**Project  
T10/1683-D**

**Information technology -  
SCSI Architecture Model - 4 (SAM-4)**

**Summary of Comments on SCSI Architecture Model - 4**

Figure 1 — Requirements precedence

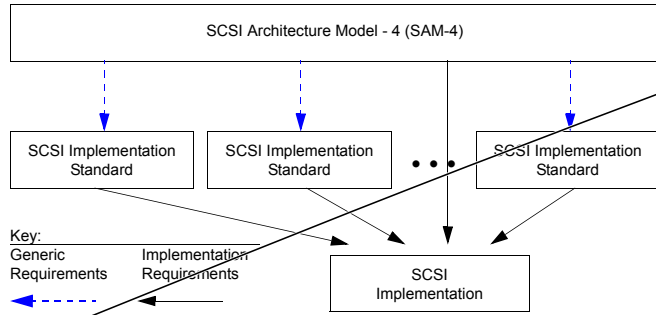
Author: Mark Evans, WDC Subject: Highlight Date: 10/25/2007 1:01:53 PM  
 Since text takes precedence in this standard, and text should introduce figures, tables, etc., I recommend moving the following paragraph above figure 1.

Status George Penokie Accepted 10/26/2007 2:31:33 PM  
 Author: Mark Evans, WDC Subject: Note Date: 10/25/2007 1:03:15 PM  
 I recommend that at least one "e.g." be added either in the four rows in figure 2, in the descriptive text that follows, or both. See SBC-3 for an example.

Figure 2 — SCSI document structure

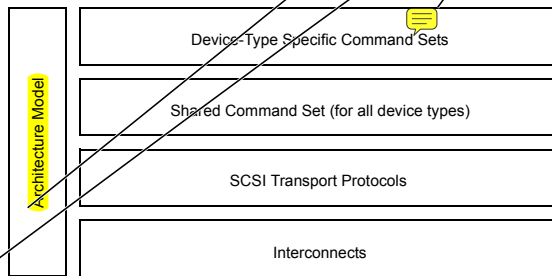
Status George Penokie Accepted 10/29/2007 3:50:40 PM  
 Author: Emulex Subject: Highlight Date: 10/30/2007 1:16:34 PM  
 Emulex-001  
 Page: 2 first sentence below Figure 2 - "roadmap" s/b "document structure"

Status George Penokie Rejected 10/29/2007 4:06:27 PM  
 Author: George Penokie Subject: Note Date: 10/26/2007 2:33:21 PM  
 Copied the SBC-3 figure into SAM-4.

Figure 4 — Notation for association relationships for class diagrams

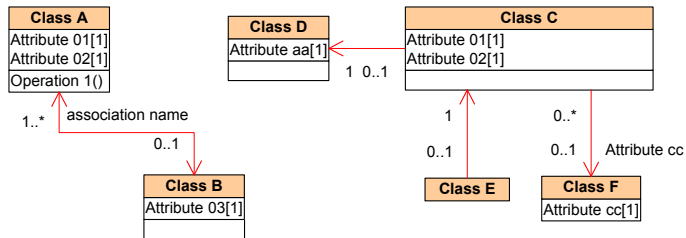
Author: Mark Evans, WDC Subject: Highlight Date: 10/29/2007 1:19:21 PM  
 \*Solid lines with arrowheads (see figure 4) are the notation...  
 sld  
 "...is the notation..." ["notation" meaning, "...any particular system of characters or symbols used to briefly express elements...", and this is my first choice]  
 or  
 "...are the notations..." ["notations" meaning, "...the characters or symbols used in such a system..."]  
 One way or the other, the verb has to agree with the object (i.e., either "is the notation" or "are the notations").  
 Status  
 George Penokie Accepted 10/29/2007 10:25:26 AM  
 Author: George Penokie Subject: Note Date: 10/29/2007 10:25:18 AM  
 Changed to "is the notation"

Figure 5 — Notation for aggregation relationships for class diagrams

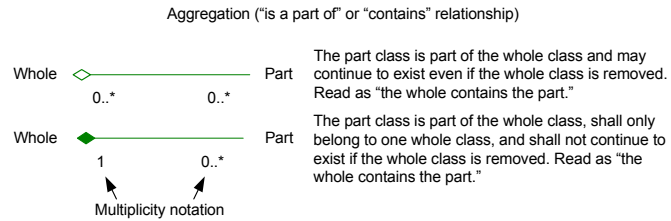
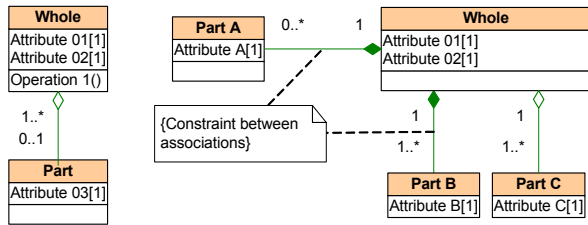
Author: Mark Evans, WDC Subject: Highlight Date: 10/29/2007 1:18:53 PM  
 \*Solid lines with diamonds (see figure 5) are the notation...  
 s/b  
 \*...is the notation... [see my earlier comment]  
 Status  
 George Penokie Accepted 10/29/2007 10:26:15 AM

Figure 12 — SCSI client-server model

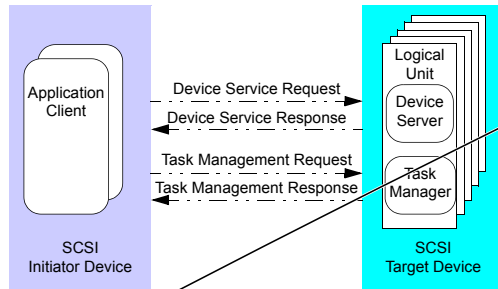
- Author: relliott Subject: Note Date: 10/28/2007 10:37:45 PM  
 The last paragraph in 4.3.1 discusses commands and device server requests. It should also discuss TMFs and task management requests, to cover everything shown in figure 12.

Figure 15 — SCSI Domain class diagram

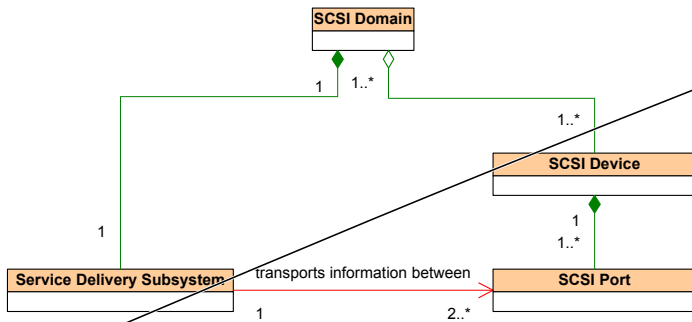
Author: relliott Subject: Highlight Date: 10/8/2007 6:53:52 PM  
 SCSI Domain class (figure 15)  
 s/o  
 SCSI Domain class (see figure 15)

Status George Penokie Accepted 10/30/2007 3:42:44 PM

Figure 19 — SCSI Initiator Device class diagram

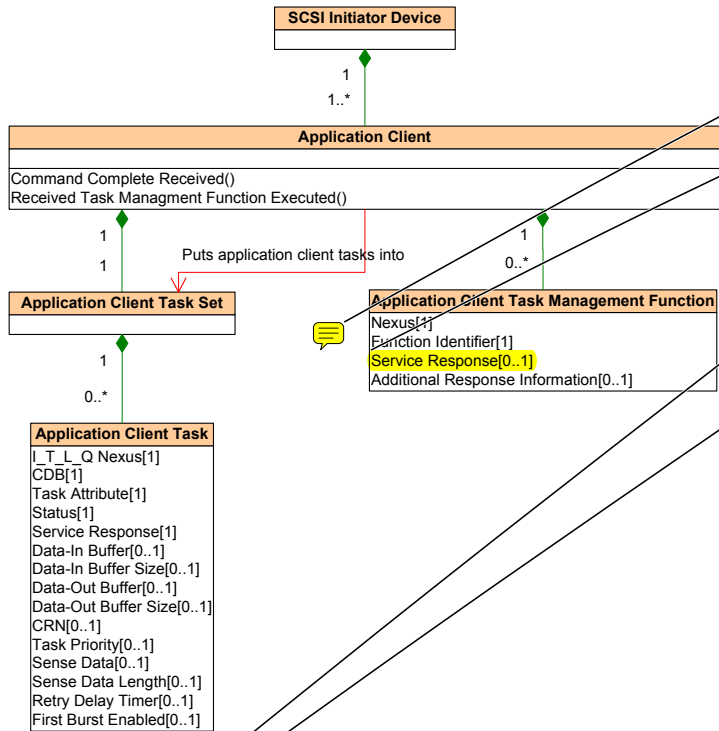
Author: reilott Subject: Note Date: 10/8/2007 6:53:04 PM  
 Nexus and Function Identifier should be swapped in figure 19 and in sections 4.5.11.2 and 4.5.11.3 to match the SCSI Target Device side in figure 22 and following sections. (or the target side should be swapped to follow this)

Figure 22 — Logical Unit class diagram

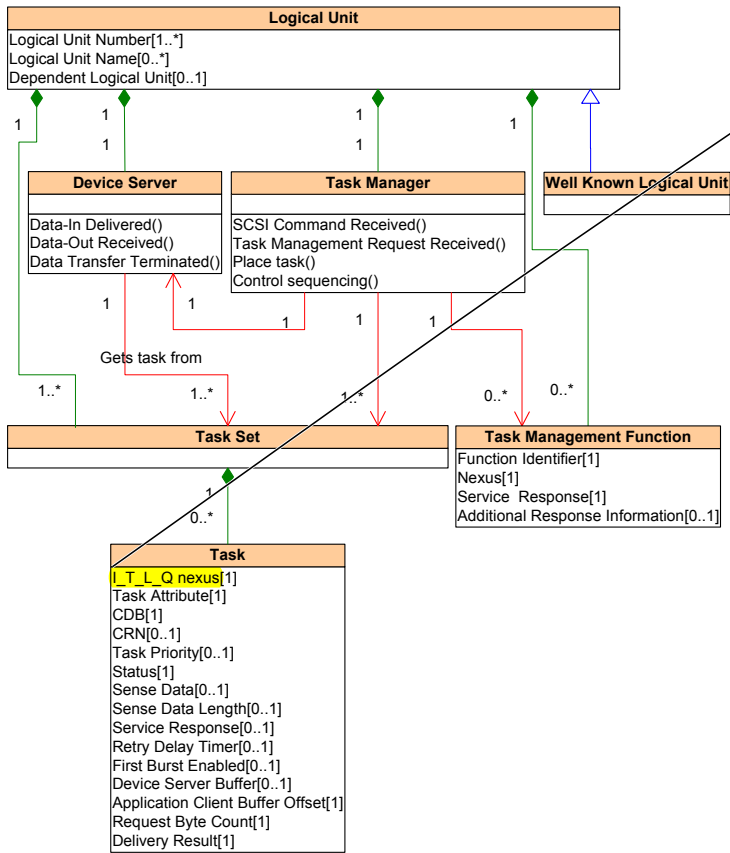
There is no class with that name, and it doesn't appear in figure 22.

Author: relliott	Subject: Highlight	Date: 10/8/2007 6:46:29 PM
4.5.24.3 should be swapped with 4.5.24.2 to match the order the attributes are listed in figure 22.		
Status	George Penokie Accepted	10/30/2007 5:11:35 PM
Author: sublerp	Subject: Sticky Note	Date: 10/25/2007 6:21:35 PM
Should this say "receives a task or a task management function specifying a W-LUN" ?		
Status	George Penokie Accepted	10/30/2007 5:13:52 PM
Author: George Penokie	Subject: Note	Date: 10/30/2007 5:13:49 PM
Yes		
Author: relliott	Subject: Highlight	Date: 10/29/2007 11:16:28 AM
selection of incorrect logical units s/b incorrect logical unit numbers		
Status	George Penokie Completed	12/26/2007 11:07:34 AM -06'00'
Author: George Penokie	Subject: Note	Date: 12/26/2007 11:16:12 AM -06'00'
Changed to << addressing an incorrect logical unit >> Changed globally. Also, changed all << incorrect logical unit >> to << incorrect logical unit number >>.

Figure 30 — SCSI target device and SCSI initiator device configured in a single SCSI domain

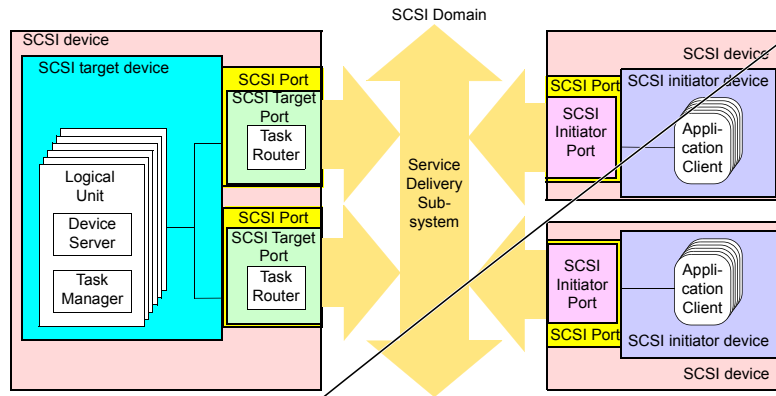
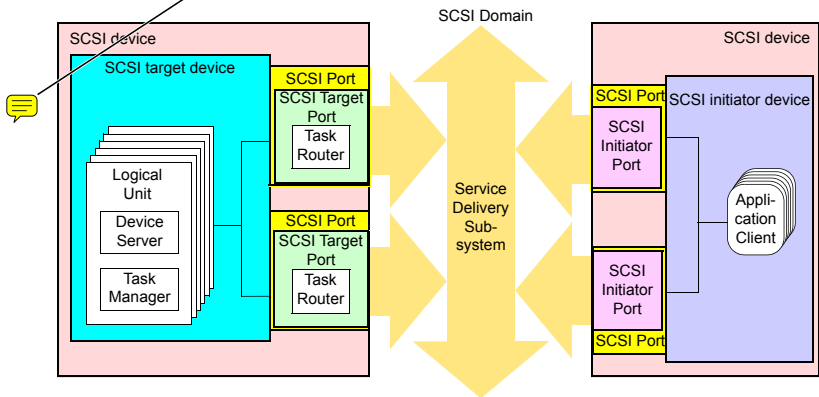
Author: Mark Evans, WDC Subject: Highlight Date: 10/25/2007 11:10:07 AM  
 \*This standard does not require a SCSI target device to have the ability to detect the presence of a SCSI initiator device with multiple SCSI initiator ports. Therefore, a SCSI target device handles a SCSI initiator device with multiple SCSI initiator ports exactly as it would handle multiple separate SCSI initiator devices (e.g., a SCSI target device handles the configurations shown in figure 29 and figure 30 in exactly the same way it handles the configuration shown in figure 28).  
 s/b  
 \*This standard does not require a SCSI target device to be able to detect that a SCSI initiator device contains more than one SCSI initiator port. In the cases where a SCSI target device does not detect that a SCSI initiator device contains more than one SCSI initiator port, the SCSI target device interacts with the SCSI initiator device as if each SCSI initiator port was contained in a separate SCSI initiator device (e.g., a SCSI target device operates in the configurations shown in figure 29 and figure 30 in the same way it operates in the configuration shown in figure 28).

Figure 4 — Notation for association relationships for class diagrams

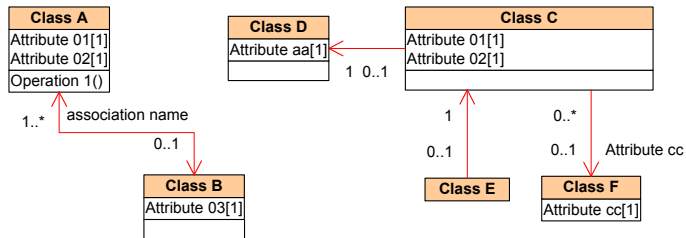
"is" is very awkward given that all the nouns on the left are plural.  
Restructure as  
\*The notation used to describe the association relationship between classes in class diagrams is solid lines with arrowheads (see figure 4).  
Apply to all the figure introductions in this section.

Figure 5 — Notation for aggregation relationships for class diagrams

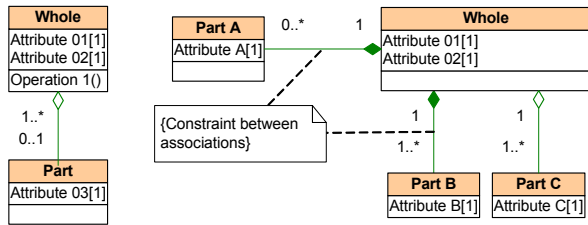
- Author: relliott Subject: Highlight Date: 3/12/2008 9:28:46 AM  
part and whole should be Mixed case
